CALL NO. 101  
CONTRACT ID NO. 111313  
ADDENDUM # 2

Subject: Jefferson County, HPP 0163 (032)  
Letting April 22, 2011

- (1) Revised - Plan Sheets - C4001, C5001, CS1000, CS1001, & G0002
- (2) Revised - Note - Pages 320-331 of 471
- (3) Added - Addendum No. 2 - Pages 426(g)-426(p) of 471
- (4) Revised - Bid Items - Page 471 of 471

**The Parklands of Floyds Fork - Project 2A**  
 Beckley Creek Park - North  
 Louisville, Kentucky  
 Owner:  
 21st Century Parks, Inc.  
 471 W. Main St., Suite 202  
 Louisville, Kentucky 40202

**CULVERT SECTIONS**

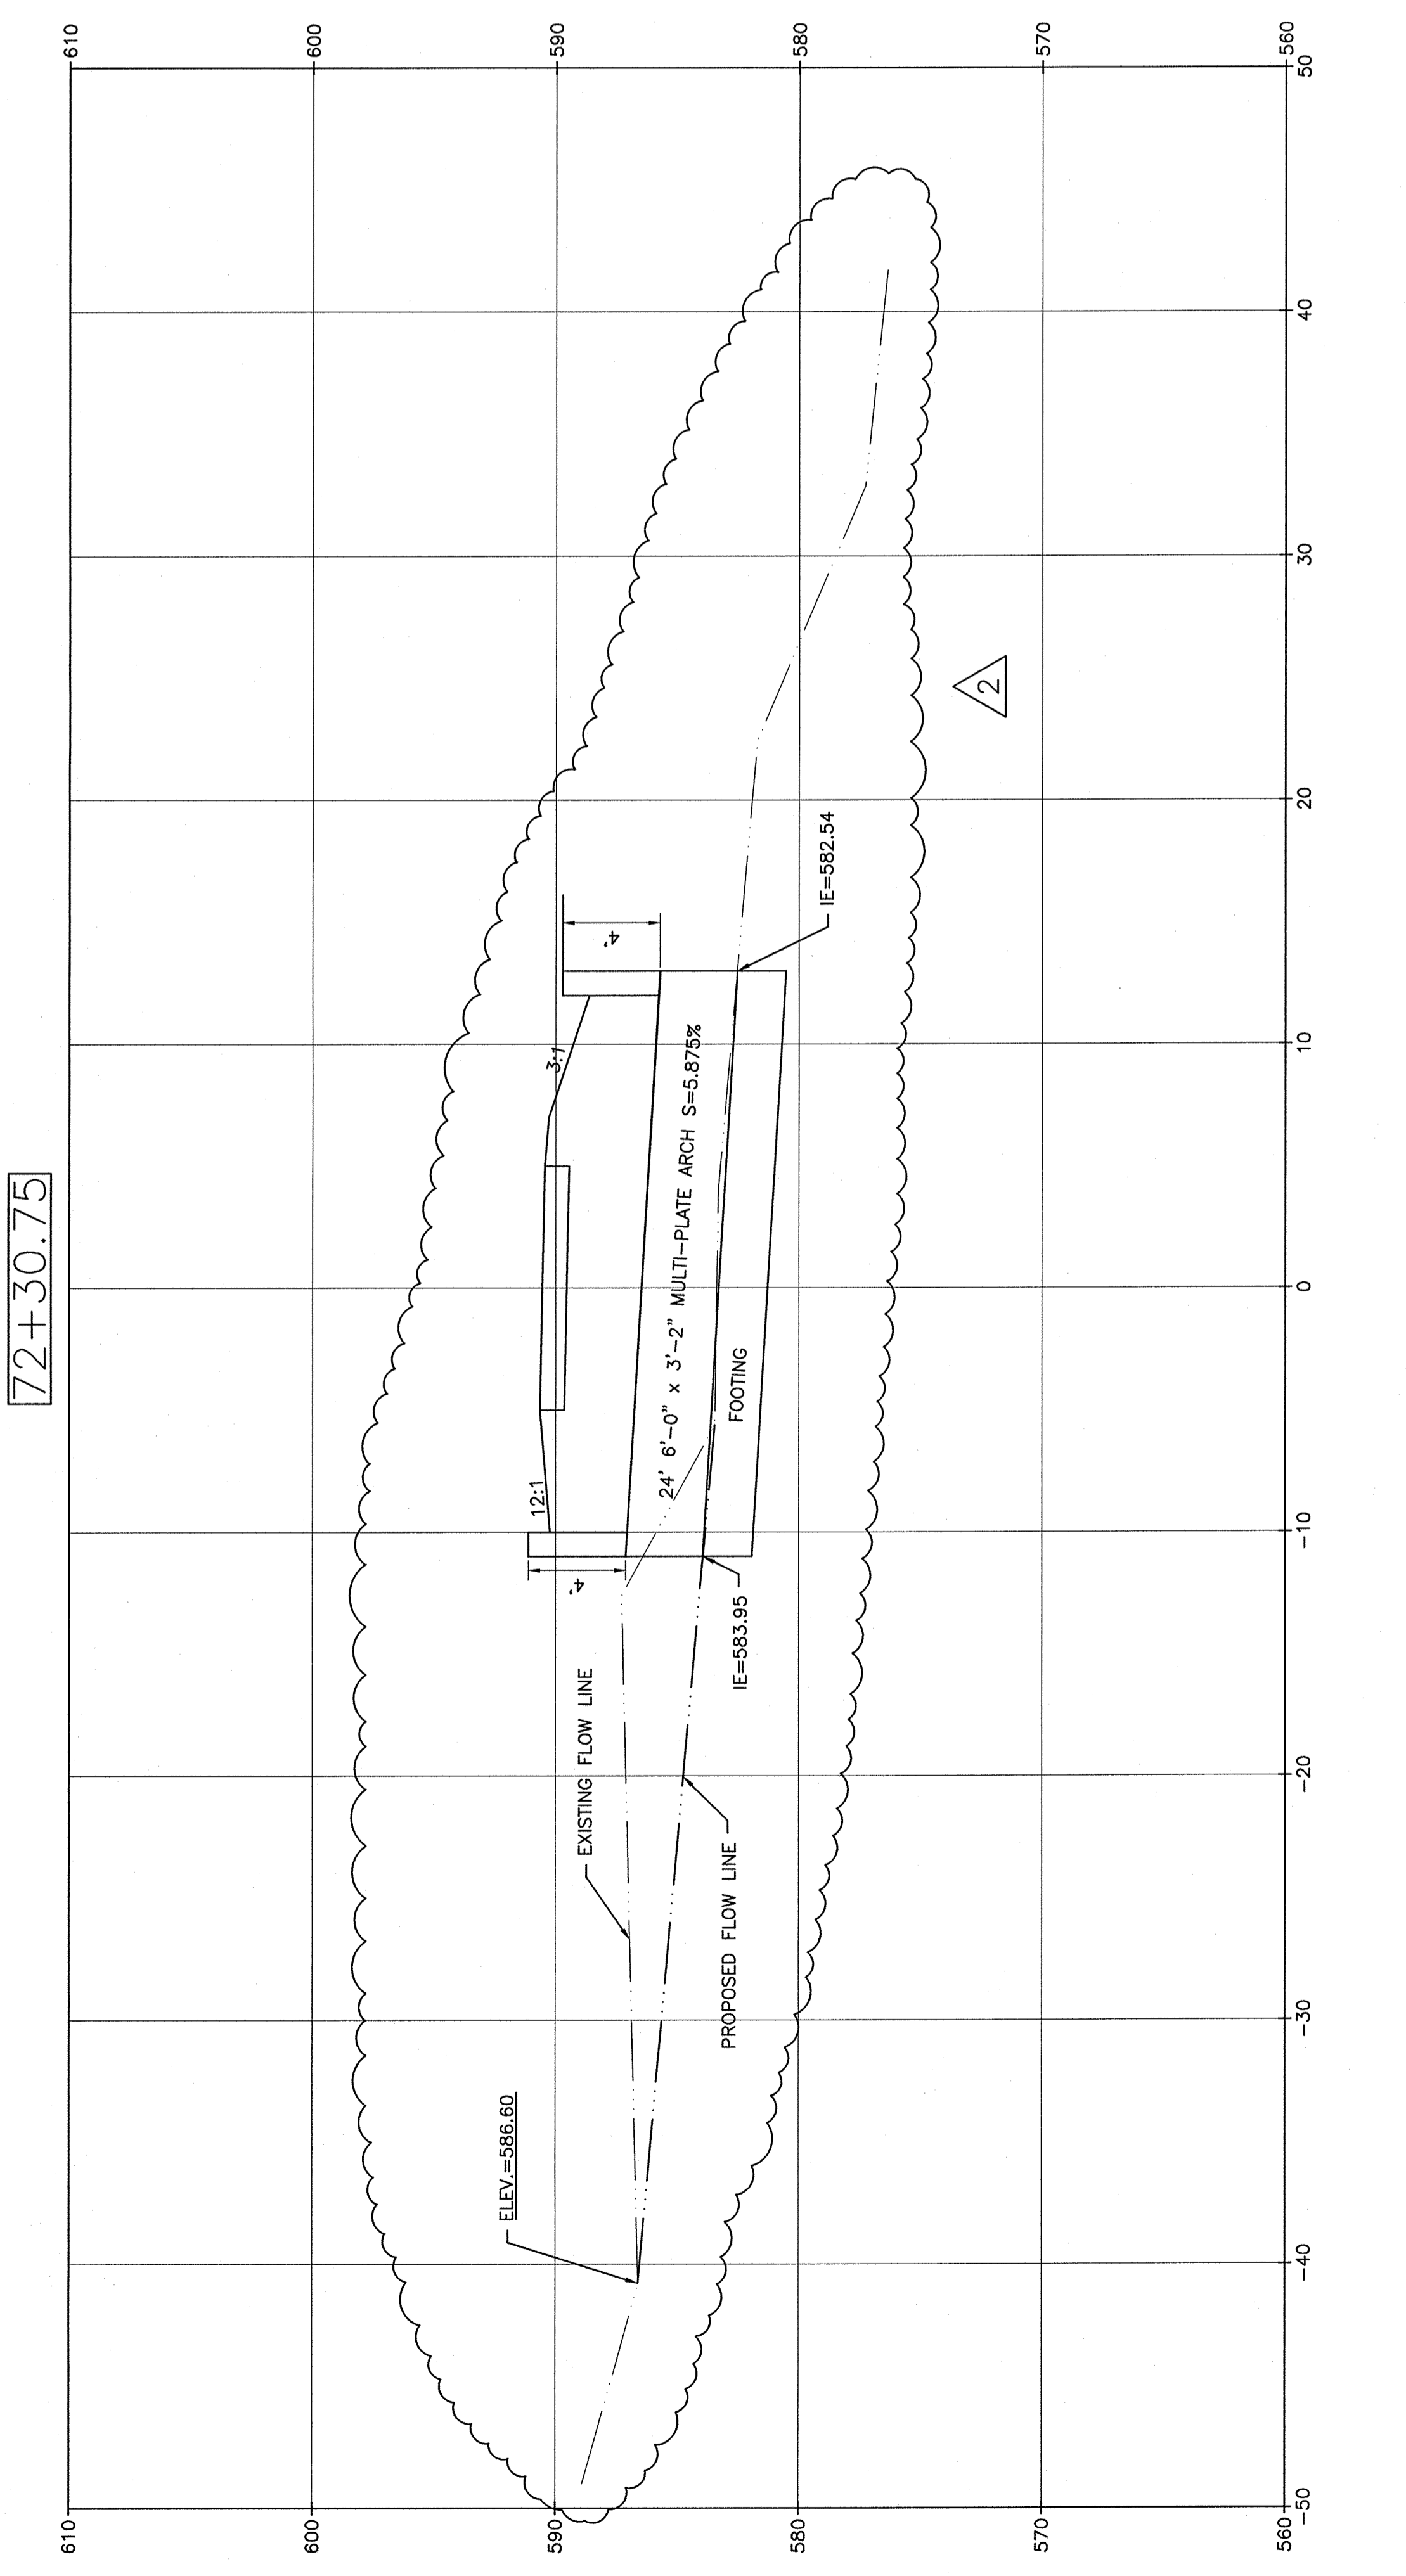
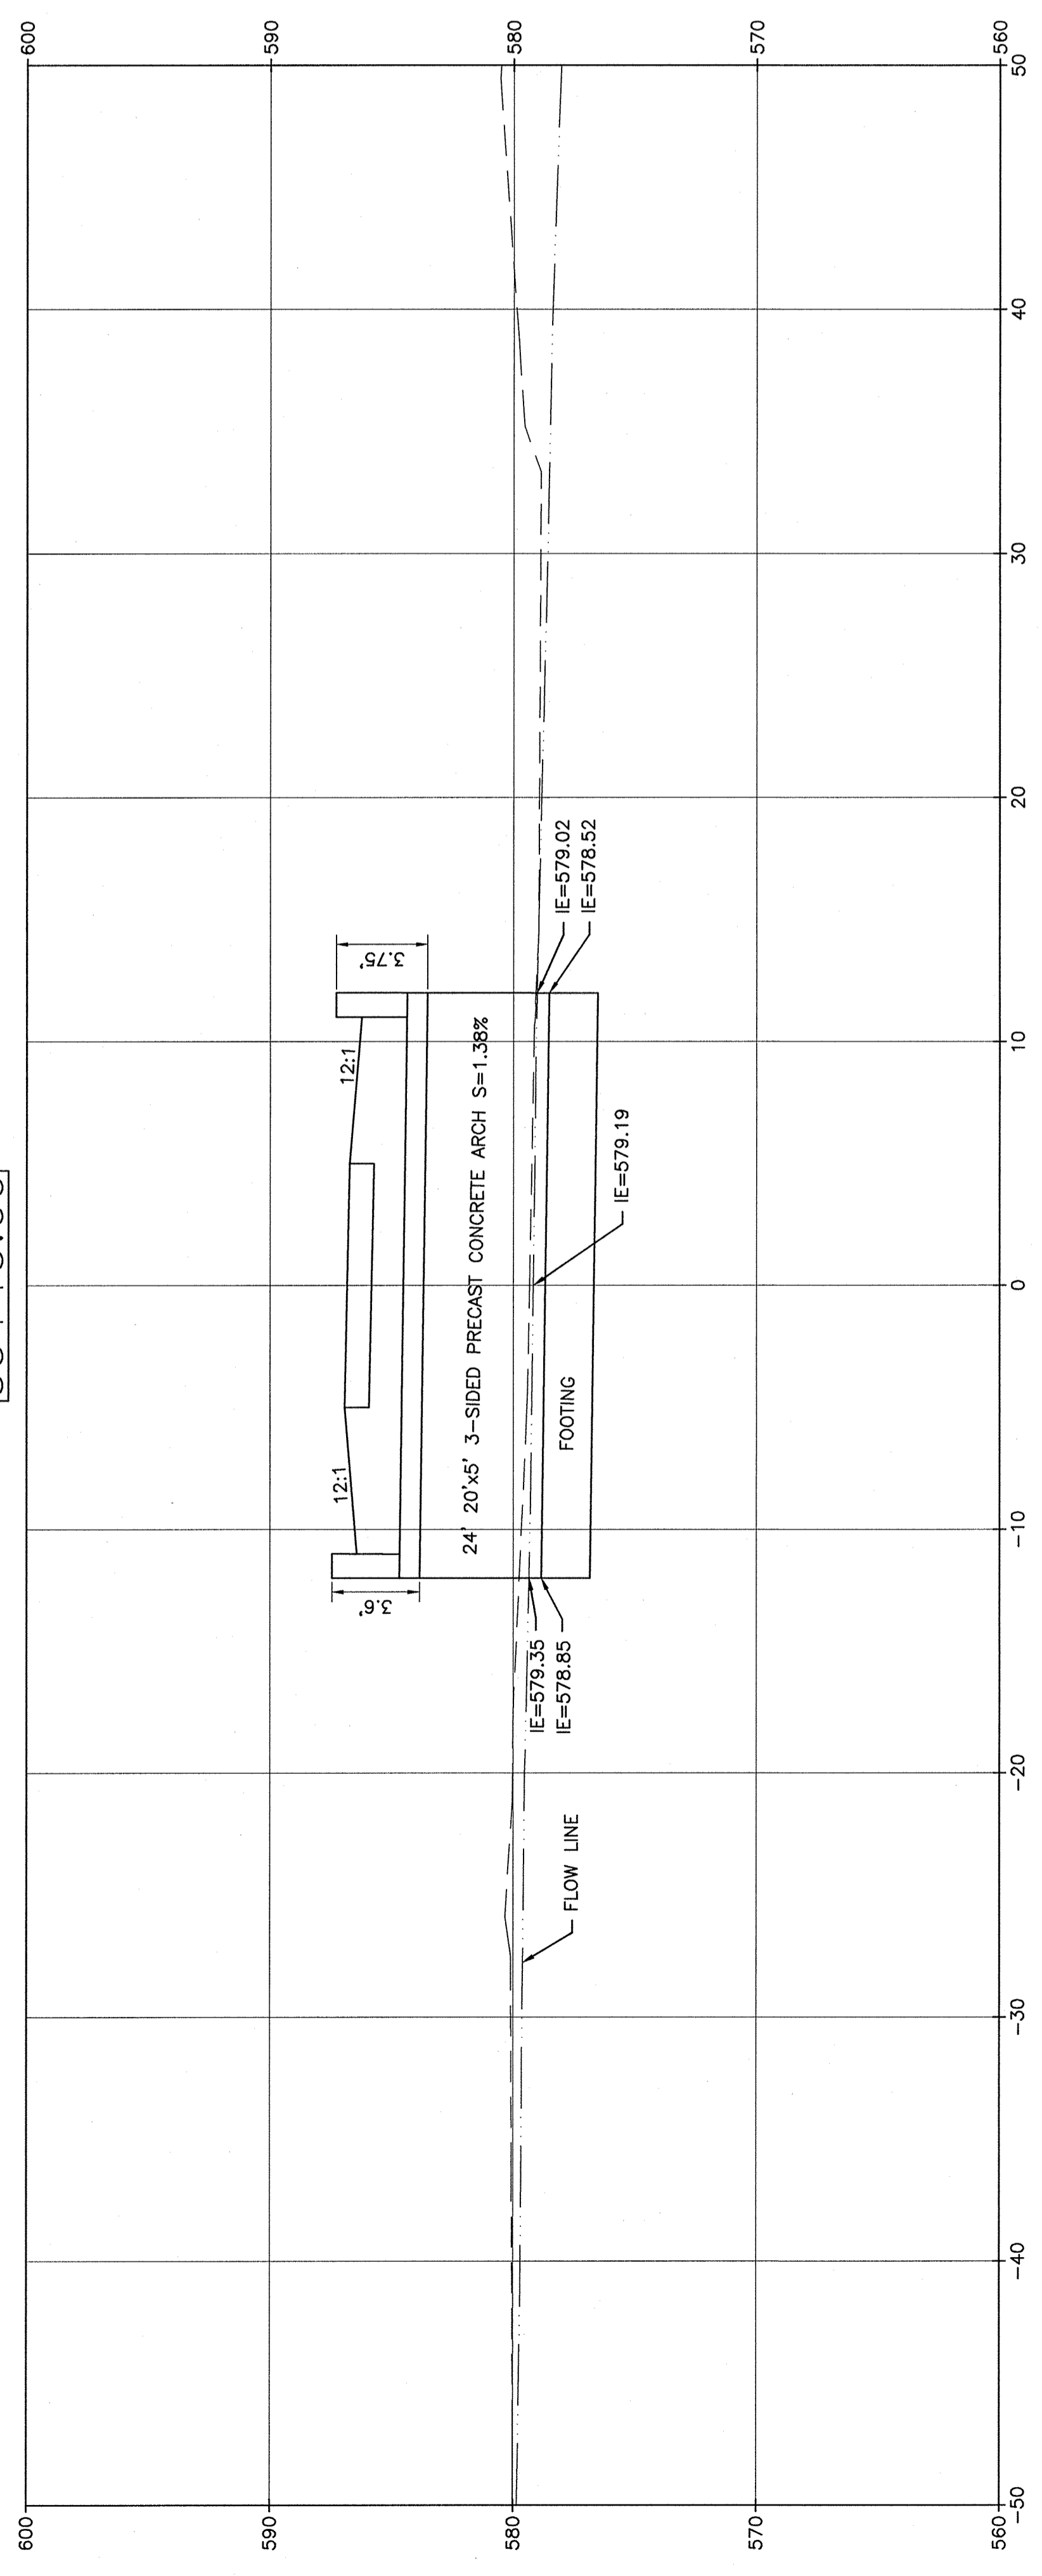
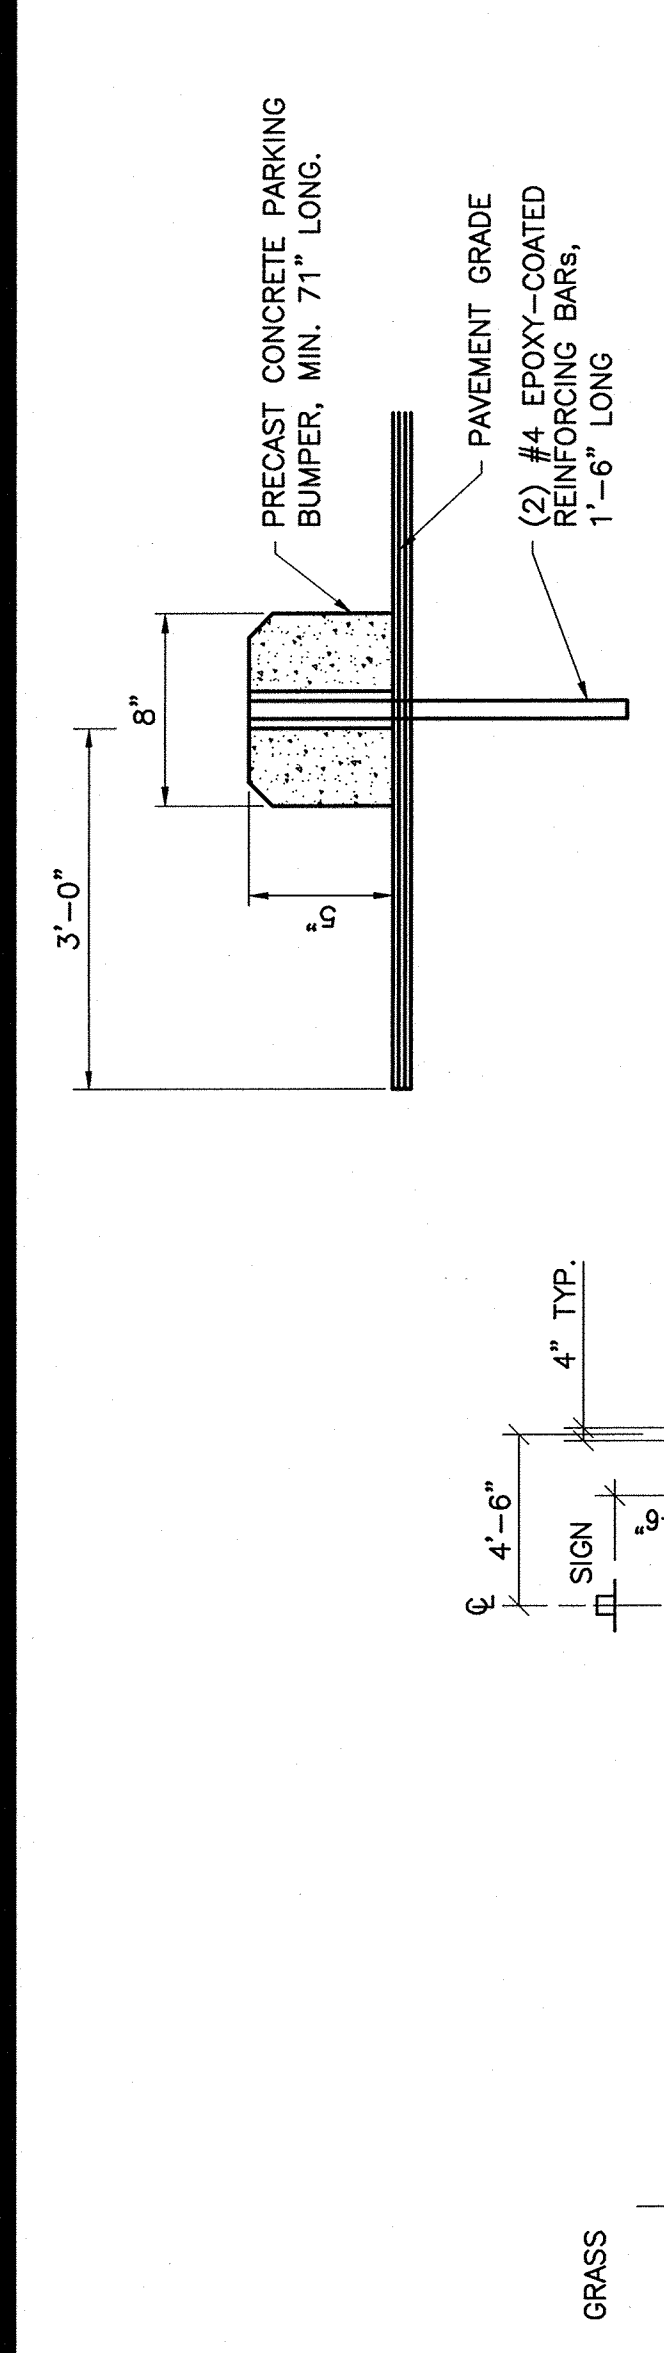
The profile for culvert section for the Multi-plate arch (Sheet C-4001) indicates excavation for a flow line upstream and downstream from the culvert. The grading plan (Sheet CG-1013) does not show new contouring at the ends of the culvert. What is intended - what are the upstream and downstream limits of ditch excavation and what is the ditch cross section?

The existing flowline of the ditch that runs through the arch is being modified to represent the existing condition. At the inlet & upstream of the existing railroad tie bridge at this location and the proposed arch, debris has collected over time in the flowline. This debris is to be removed and the channel restored to its original section. The ground line shown above the Flow Line on the Multi-plate Arch section has been removed. Also the right shoulder & sideslope of the pavement section at the culvert is revised to show a 2' shoulder and 3:1 sideslope to the proposed headwall. A revised Sheet C-4001, showing these revisions, will be included in the next Addendum.

Job No: 05738.05  
 Date: 3/29/11  
 Scale: AS NOTED  
 Drawn By:  
 Checked By:  
 Drawing Title:  
**LAYOUT,  
 GEOMETRY,  
 SIGNAGE,  
 STRIPING &  
 MARKING  
 NOTES**  
 Drawing No: **CS-1000**

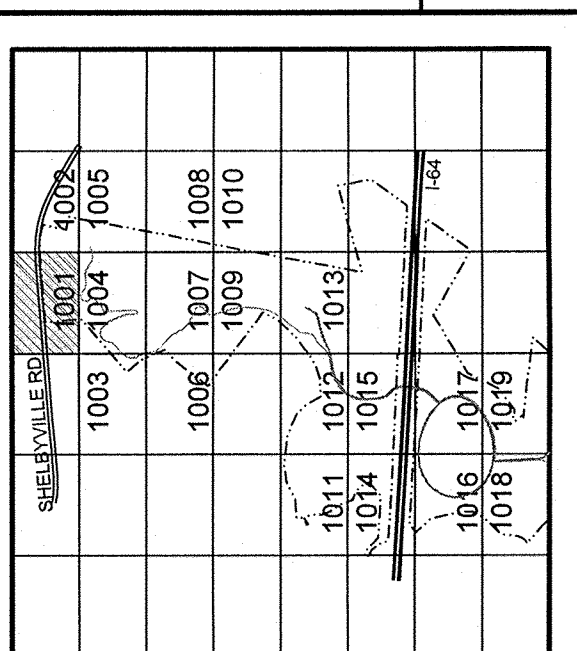
Added Signage Number “21”, Sign “LEFT TURN | RIGHT TURN ONLY”, MUTCD Code “R3-8”, Comment, “W/ ARROW SYMBOLS”.  
Pavement Marking Number 36 - ACCESSIBLE PARKING SPACE, revised MUTCD Code to “10-22\*” and added Comment “THERMOPLASTIC”.  
Added Pavement Marking Number “40”, Marking “LEFT TURN ARROW”, MUTCD Code “10-10\*”, and Comment, “THERMOPLASTIC”.  
Added Pavement Marking Number “41”, Marking “RIGHT TURN ARROW”, MUTCD Code “10-10\*”, Comment, “THERMOPLASTIC”.  
At the bottom of table added note “\* STANDARD HIGHWAY SIGNS MANUAL”.
